MONTGOMERY COUNTY HISTORIC PRESERVATION COMMISSION
STAFF REPORT

Address:	10201 Menlo Ave.	Meeting Date:	11/14/18
Resource:	Vacant lot Capitol View Park Historic District	Report Date:	11/7/18
Applicant:	Minter Farnsworth	Public Notice:	10/31/18
Review:	HAWP	Tax Credit:	n/a
Case Number:	31/07-18F	Staff:	Dan Bruechert
Proposal:	New Construction

PROPOSAL

Figure 2: The subject lot with the identified easements and other limitations. Zoning restrictions are shown in orange, the conservation easement is in olive, the sewer easement is in red, the water easement in blue, and the storm drain in yellow.

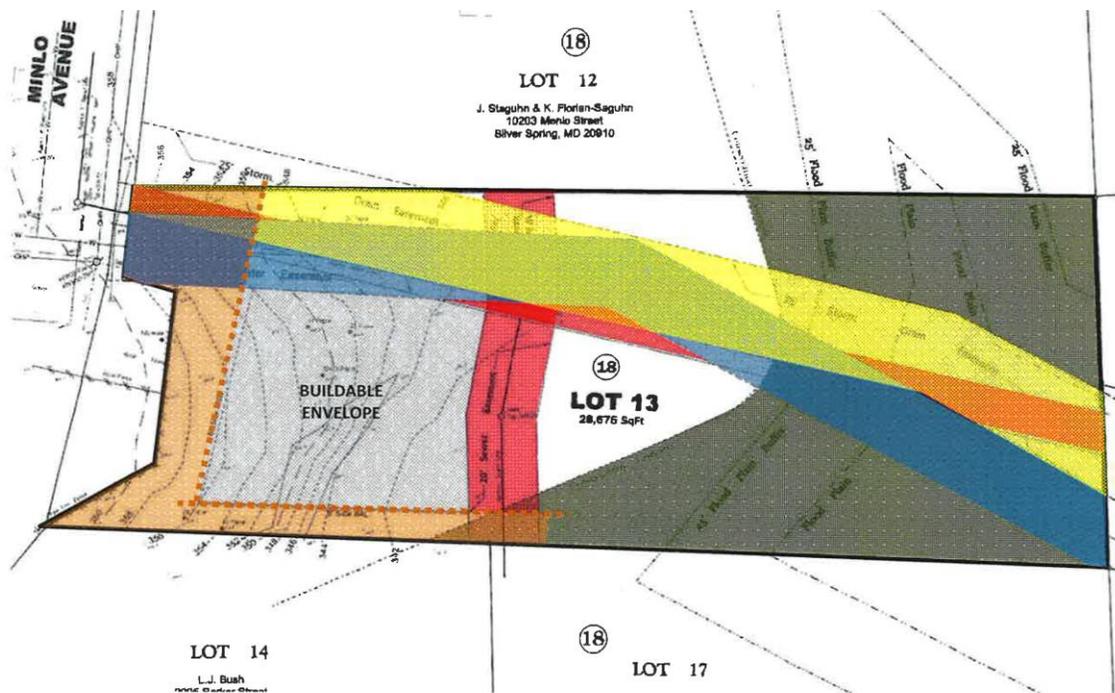
In order to accommodate the proposed construction, the application proposes to remove a total of nine trees on the site. Four of these trees are located at the entrance to the lot and have to be removed to provide access to the site. Staff finds that to deny the applicant the ability to remove these trees would deny any reasonable use of the subject property, contravening 24A-8(b)(5). Another three trees are at the center of the buildable envelope and any house construction on the site would require the removal of these trees. Two more trees proposed for removal are located near the southern property boundary within the limits of disturbance. Staff finds that the proposed tree removal will impact the character of the site. However, Staff finds there are several mitigating measures to be considered. First, under the forest conservation program, the applicant is required to re-plant trees one-for-one or pay a fee in lieu. Staff recommends that a maximum number of trees be re-planted on the site and that the species and placement be included with the submission of permit drawings for stamping. Second, the conservation

easement that encompasses the rear third of the lot may not be impacted by any of the work on the site or construction and will maintain it's wooded character. Staff supports the removal of these trees as part of the work proposed under this HAWP.

4. Staff recommends that a maximum number of trees be re-planted on the site and that the species and placement be included with the HAWP application; and

Figure 3: Setback study demonstrating the range of setbacks along Menlo Ave.

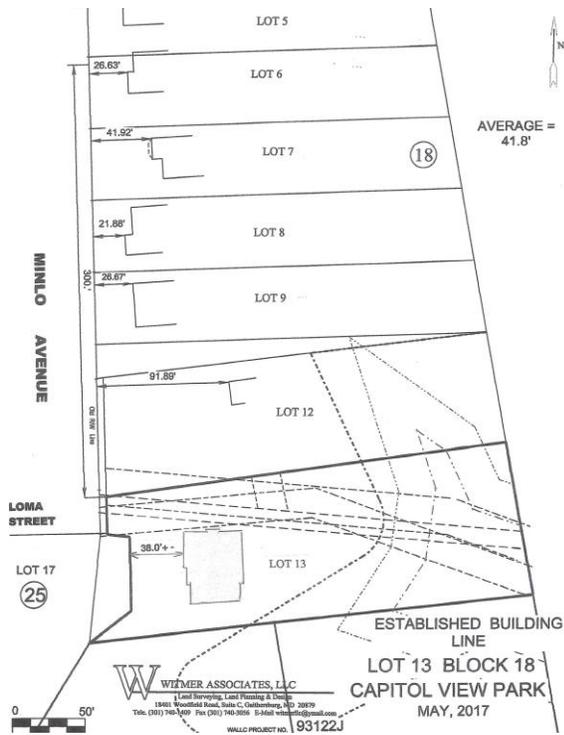
The applicant included a setback study (shown below) with the application materials. The setbacks on this section of the historic district range from approximately 22' from the street (twenty-two feet) to nearly 92' (ninety-two feet). While the setback of the proposed construction is slightly deeper than many of the late 18th century and 1920s houses further up the block, it is within the range of adjacent setbacks 38' (thirty-eight feet) and should be considered compatible. Staff finds that the setbacks alone should not be used as a sole factor to determine compatibility because this particular lot has so many additional encumbrances (easements, zoning requirements, utility lines) that severely limit many further alterations to the setbacks.

Figure 4: Streetscape study along Menlo Ave.

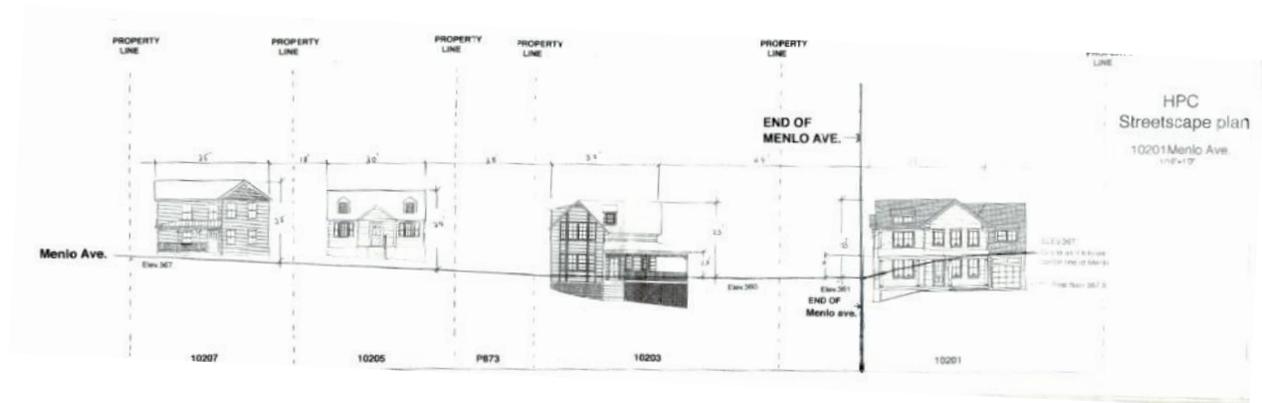
The proposed construction will be 23' (twenty-three feet) above the grade of Menlo Ave. Staff finds that the height is generally consistent with the surrounding district (see the streetscape study below).

Staff finds the height of the proposed building above street grade is identical to its immediate neighbor to the north (10203 Menlo Ave.) and lower than 10205 and 10207 Menlo Ave.

LEFT SIDE ELEVATION

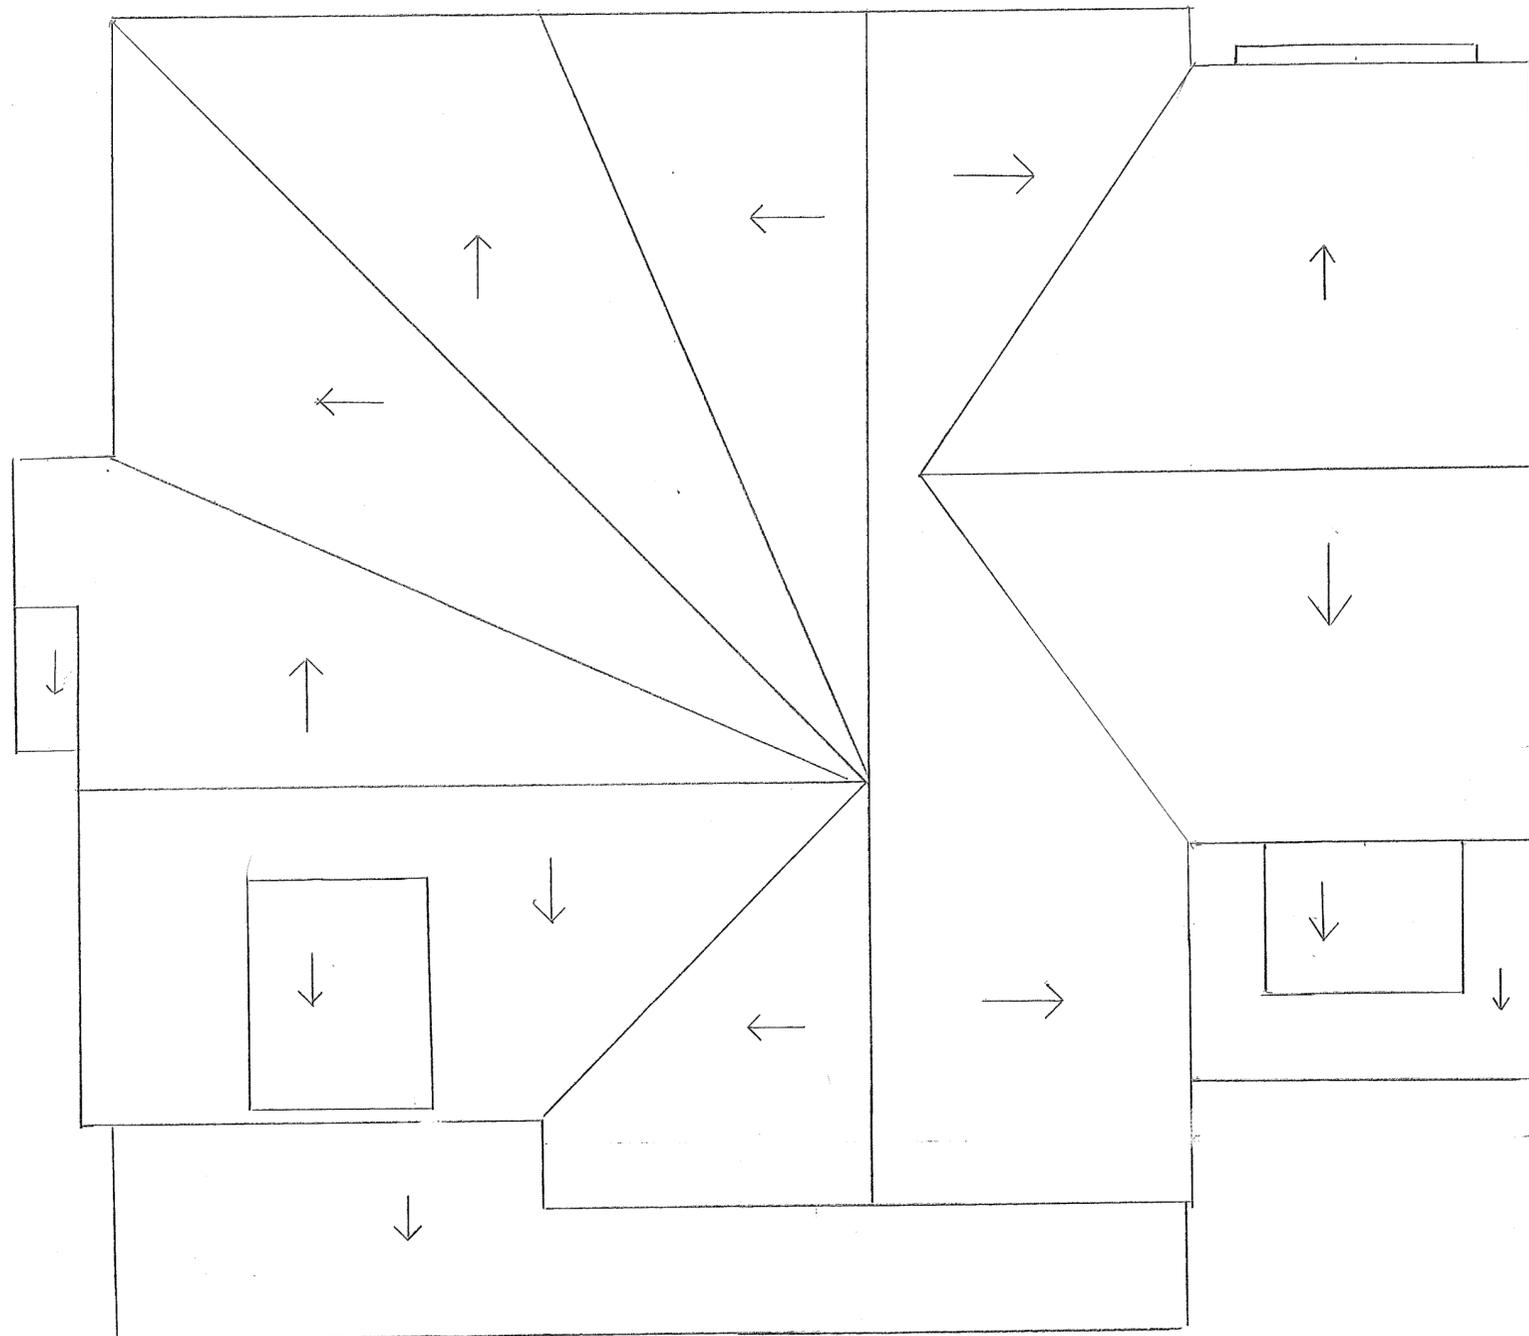
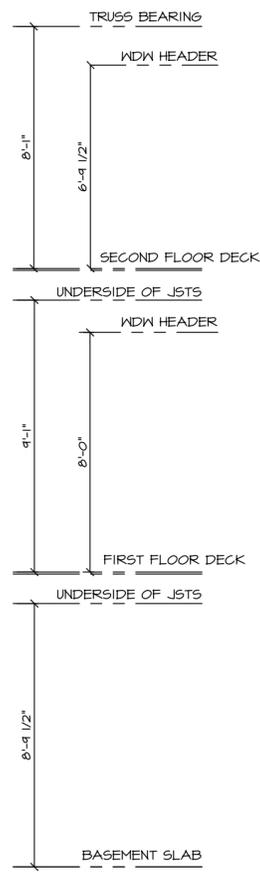
The north (left) elevation has a small projecting stair bay in the center of elevation. The bay projects 2' (two feet) from the wall plane. In front of the projecting bay, there is a two-over-two sash window on the first and second floor. To the rear of the projecting bay, each floor has two narrow, two-over-two windows. The central bay proposes to have two fixed, one-lite windows. The exposed foundation on the side elevation will be concrete with a stamped brick pattern.

Staff finds that the detailing on the north elevation is appropriate for the house and surrounding district, but recommends that the central fixed windows be altered to contain a traditionally designed window. These windows could have a decorative grille pattern similar to the image below.

2. The two windows in the north stair bay must be altered to include stained glass or a grille pattern applied to the exterior and interior of the window to be compatible with the design of the house and surrounding district. Details for the window need to be submitted for review and approval with final approval authority delegated to Staff;
